4.2.1. Position determination
Proposed modifications

AECS 12nd. meeting
Moscow, 9-11 February 2016

Part I - General requirements

Figure 4 – Diagram of path calibration

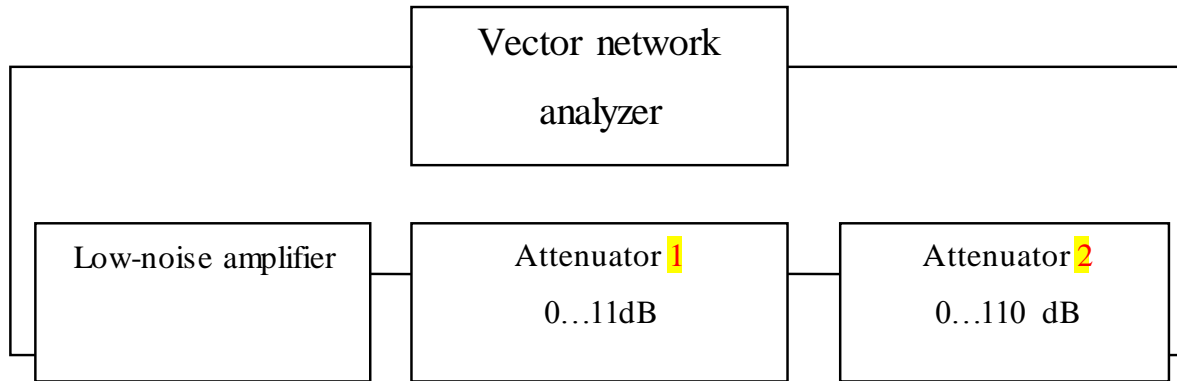
3.7.4 – Figure 5 should say: **AECD/AECS** (*instead of The AECD*)
